PROJECT NO. 23116
HOSSACK ARCHITECTS

ADDENDUM NO. 2

Issued by email Wednesday September 18, 2024

FIRE STATION 124-
MISSISSAUGA FIRE &
EMERGENCY SERVICES
PRC004616 - Construction
Services for New Fire
Station 124

FOUNDATION PLAN

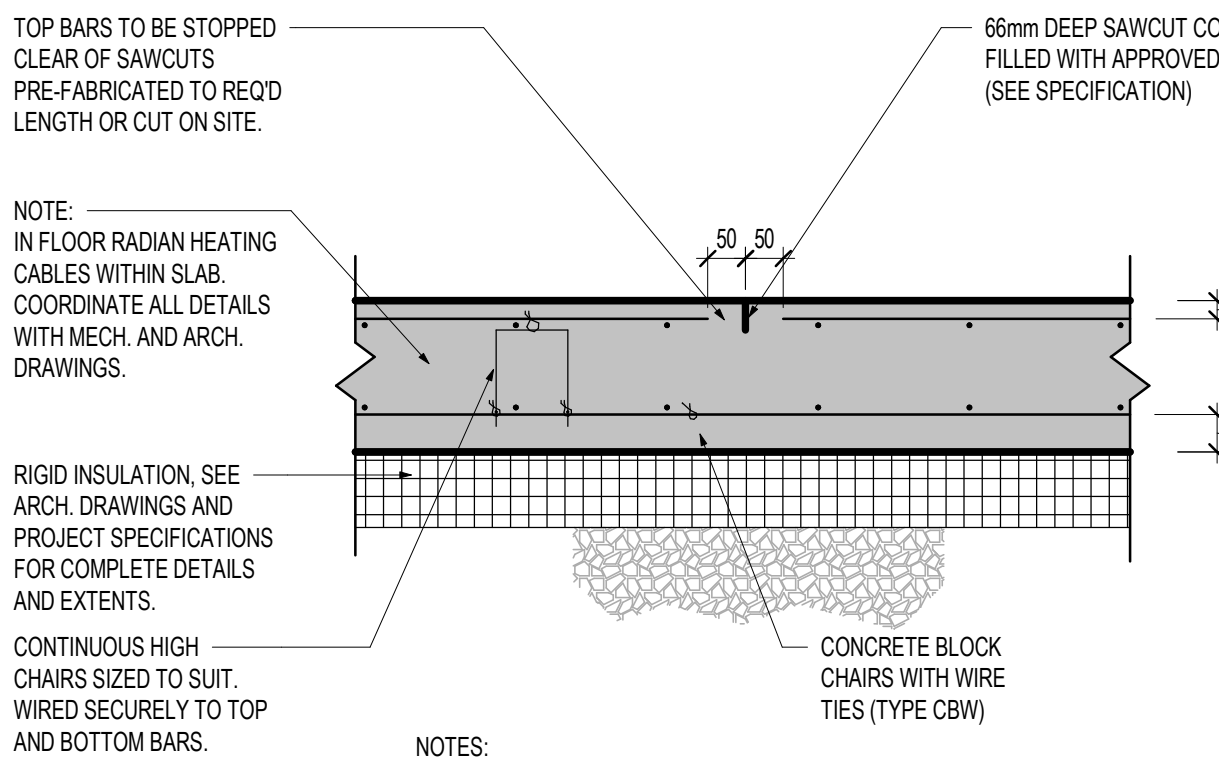
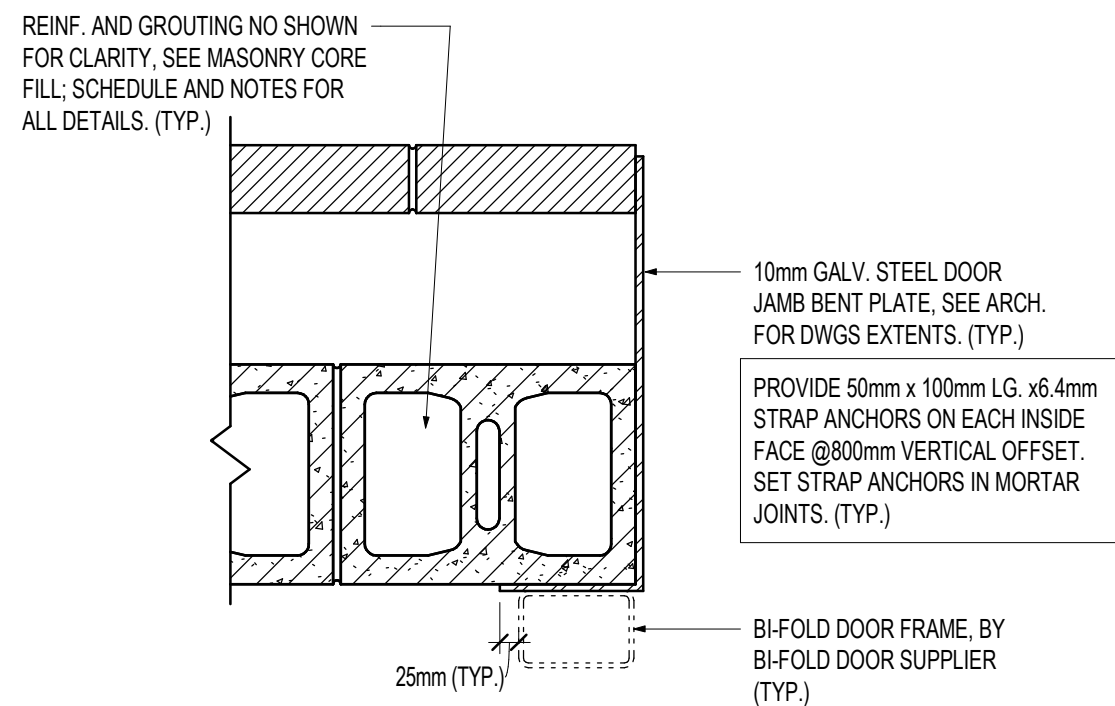
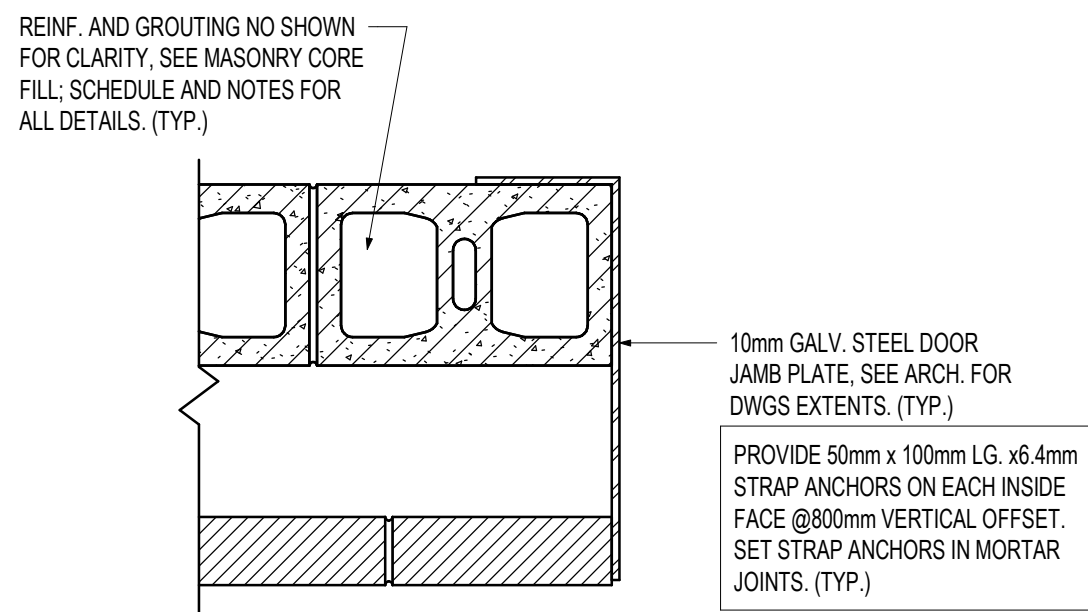
1.0 REFERENCE STRUCTURAL DRAWING S1-01 (RE-ISSUED)

- .1 Footing elevations added/clarified. See Clouded Areas

1F SECTION
S2-01 1:20

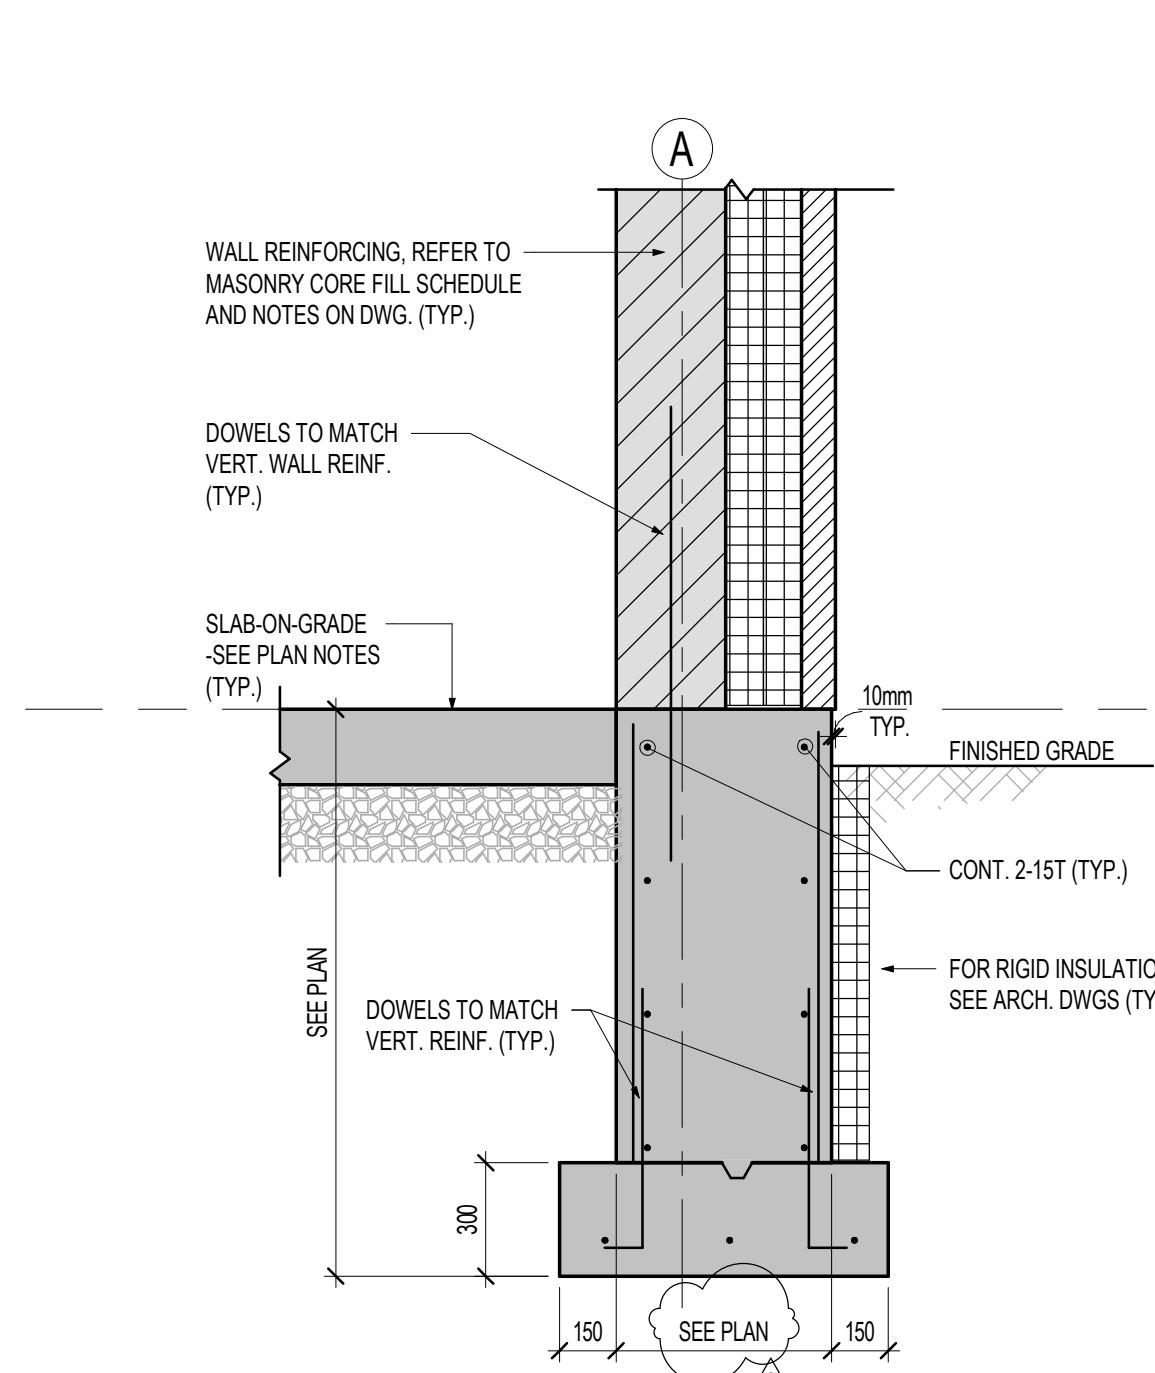
- .1 Section 1F edited to note 'See Plan' for foundation wall width. See clouded area.
- .2 Retaining wall section added to plan. See Clouded Area. Coordinate all extents with Civil and/or Architectural drawings.

1 DETAIL
S2-01 1:20

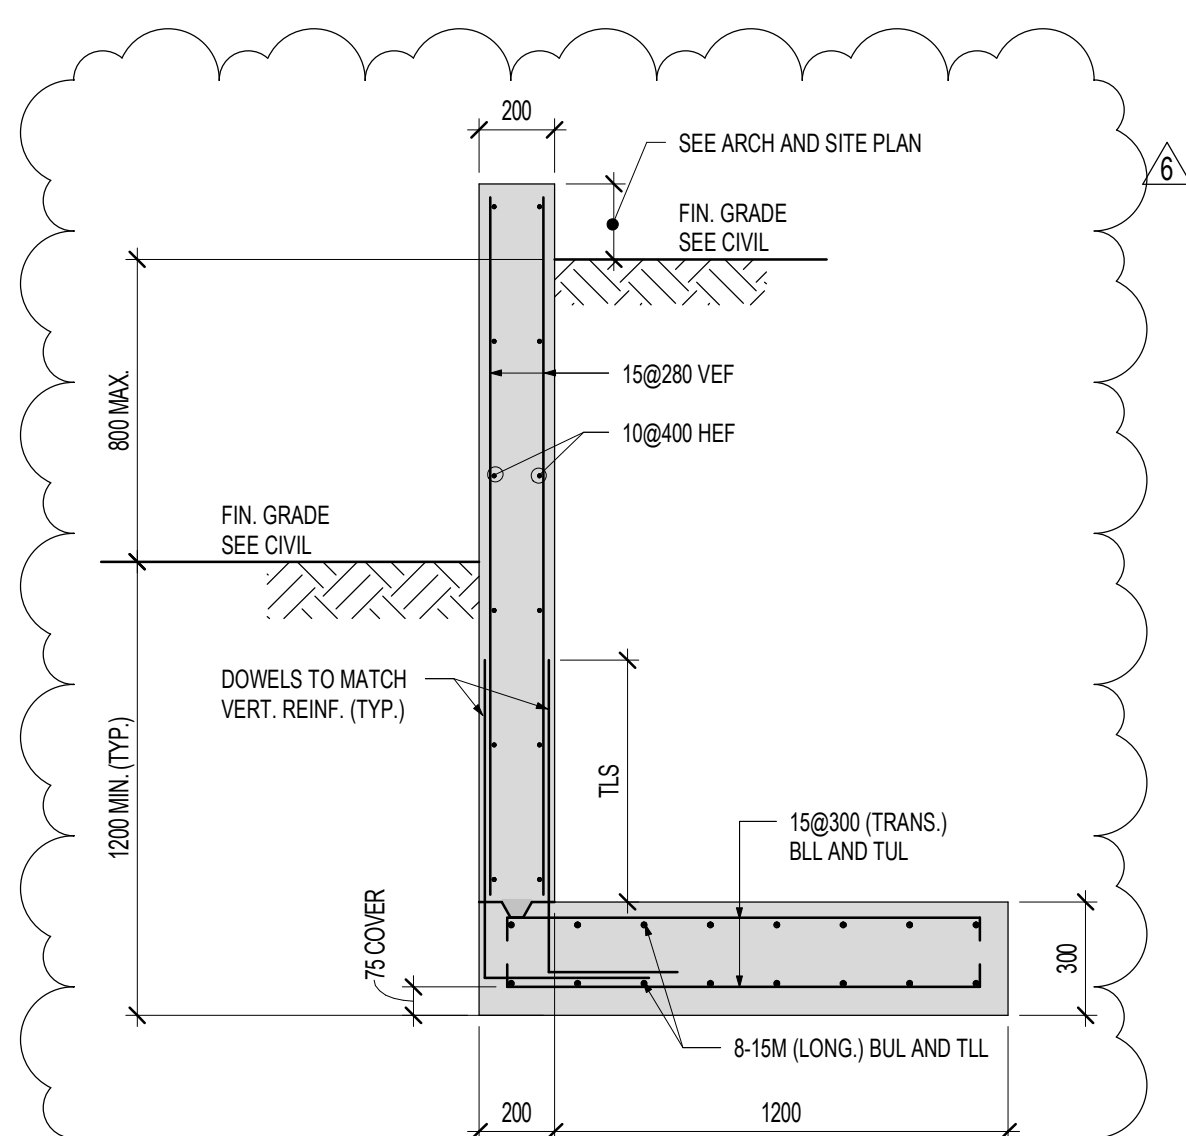
RETAINING WAL SECTION
SEE CIVIL AND/OR ARCH. DRAWING FOR EXTENTS AND DIMENSIONS
